TEXAS UTILITIES GENERATING COMPANY
SKYWAY TOWER • 400 NORTH OLIVE STREET, L.B. 81 • DALLAS, TEXAS 75201

Subject: NRC Staff Request for Additional Information on
Comanche Peak Response Results Reports for ISAPs (I.a.4,
I.b.3, II.b, III.d and VII.b.2) dated April 28, 1986.

REQUEST FOR ADDITIONAL INFORMATION FOR THE FIVE ISAP RESULTS REPORTS (I.a.4, I.b.3, II.b, III.d, and VII.b.2) AND FUTURE RESULTS REPORTS.

Separation Sketch "A"

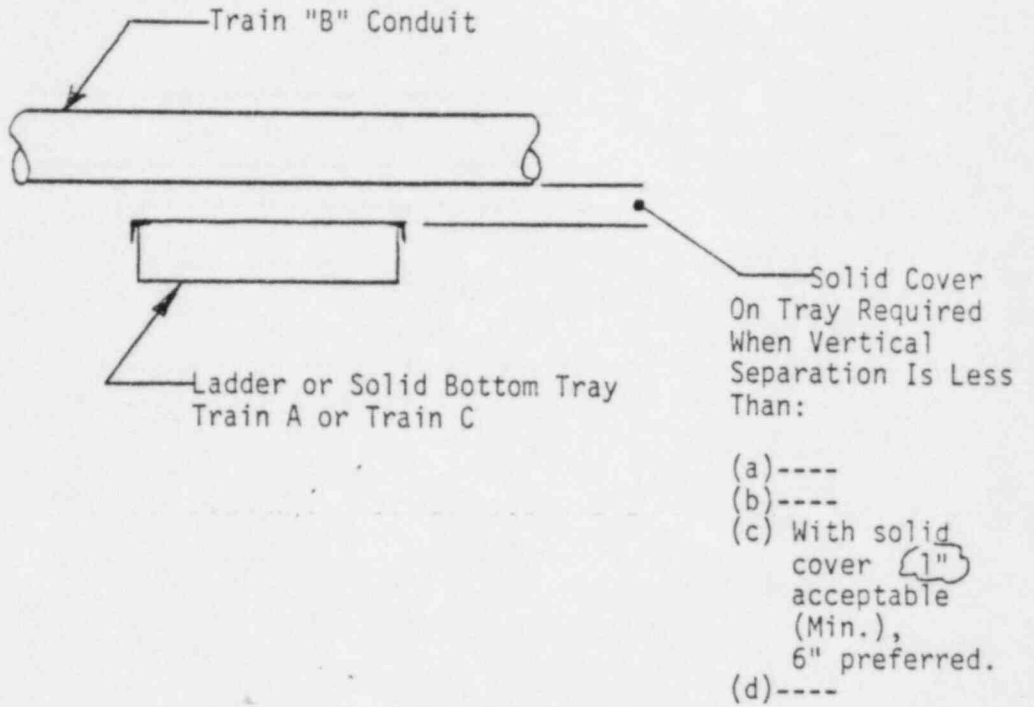
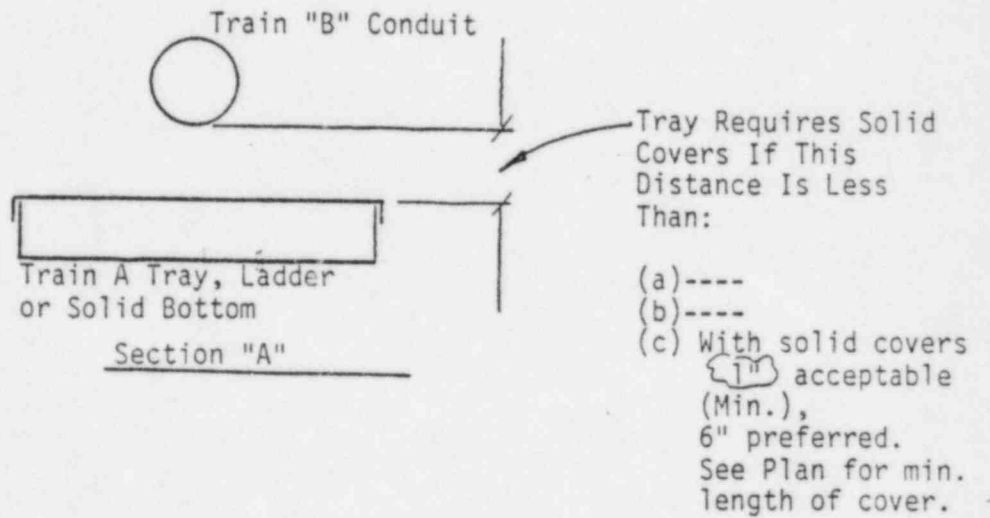
(2) Minimum separation between a conduit containing safety related cables and the top of an open tray having different train or channel shall be 2'-0" in cable spreading room and 3'-0" in general plant area. When it is impossible to maintain this separation, the distance may be reduced to one (1) inch where a solid cover is provided (see Dwg.2323-E1-1702-01, detail 38). Minimum separation between a conduit containing safety related cables and the bottom or side of an open tray (solid bottom or ladder) having different train or channel shall be one (1) inch. When a conduit containing non-safety related cables is above, beside, or below an open tray (solid bottom or ladder) having different train or channel.

See Separation Sketches "A" and "B".

Case c) Conduit Maximum Temperature versus Time at the point of maximum temperature (z = 2.33 ft)

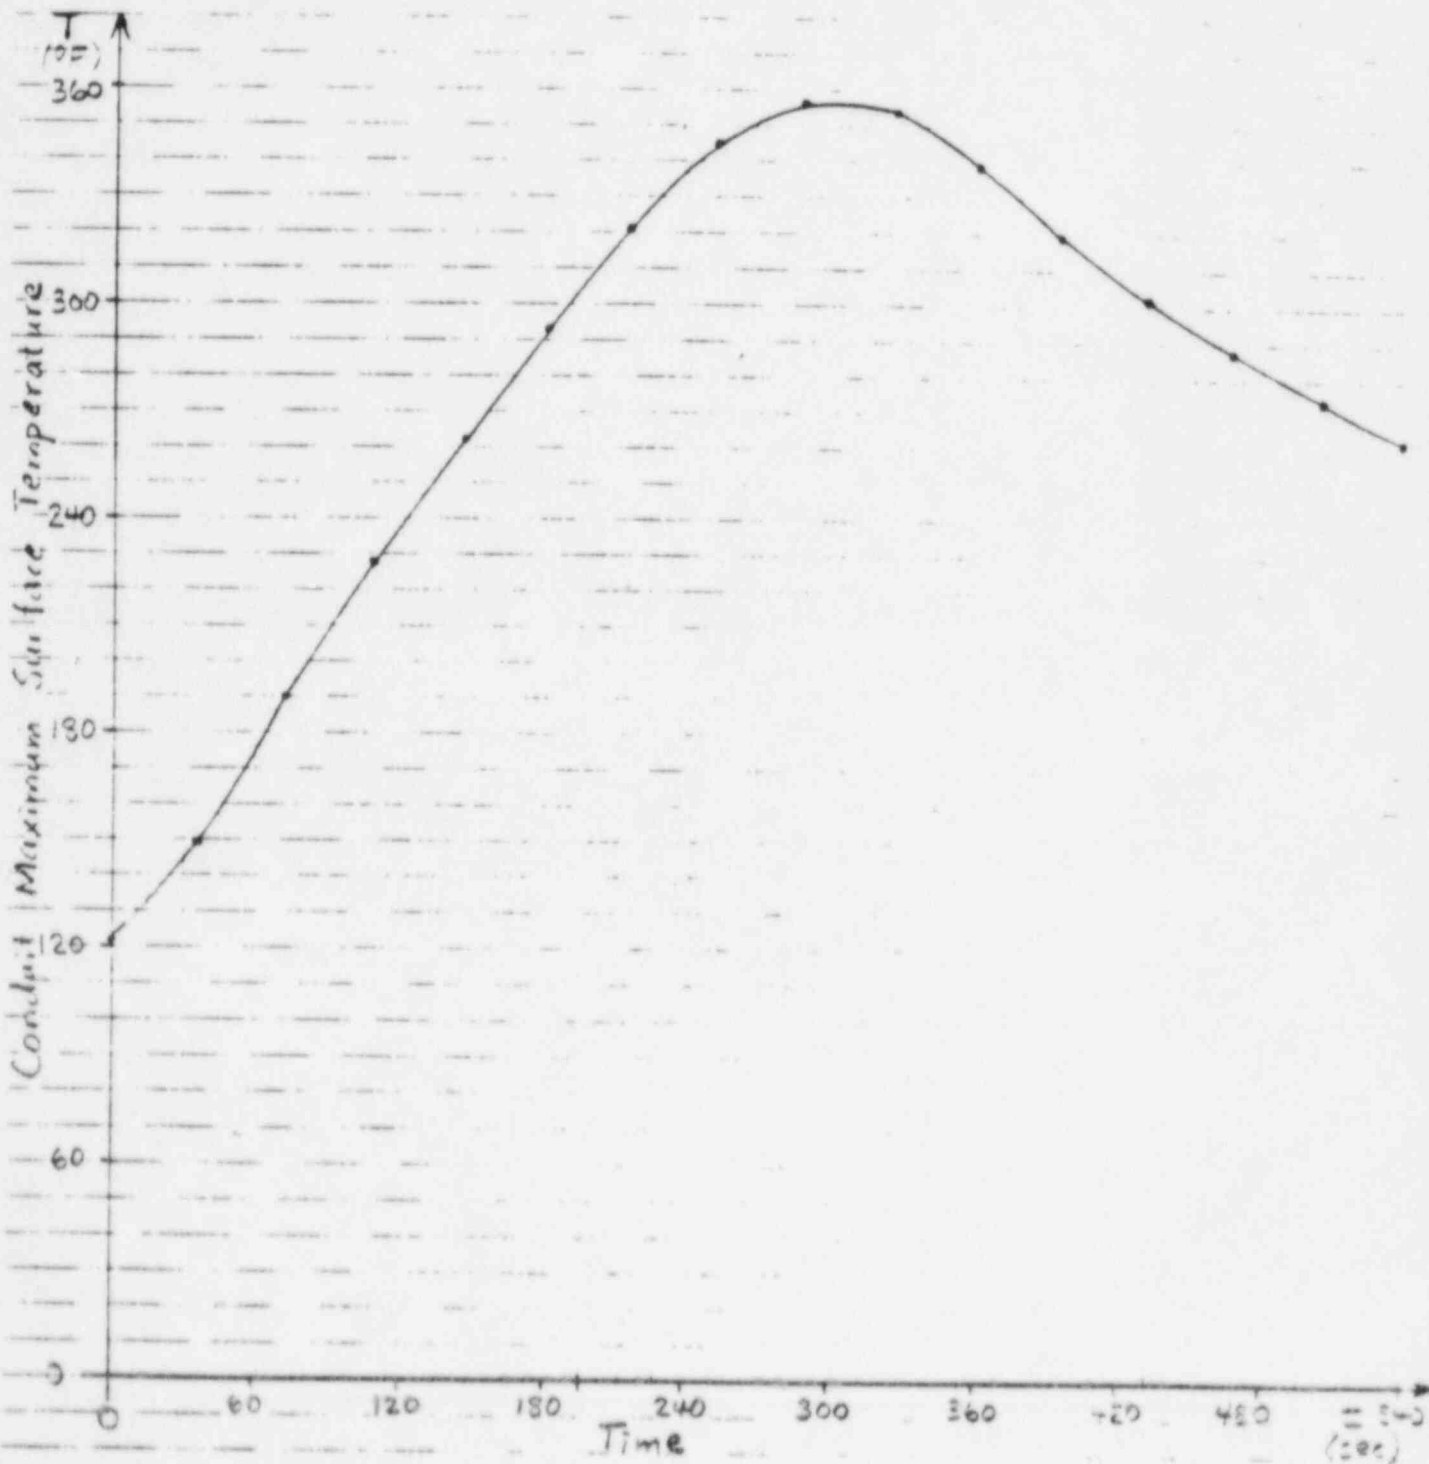
- 2) The Gibbs & Hill analysis eventually used to verify the adequacy of a one-inch separation between conduits and cable trays contained inconsistent assumptions after design review was complete. The latest revision of this analysis is attached to letter GTN-70439 dated August 20, 1985, and the Design Review confirmation was transmitted via GTN-70614 dated September 23, 1985.
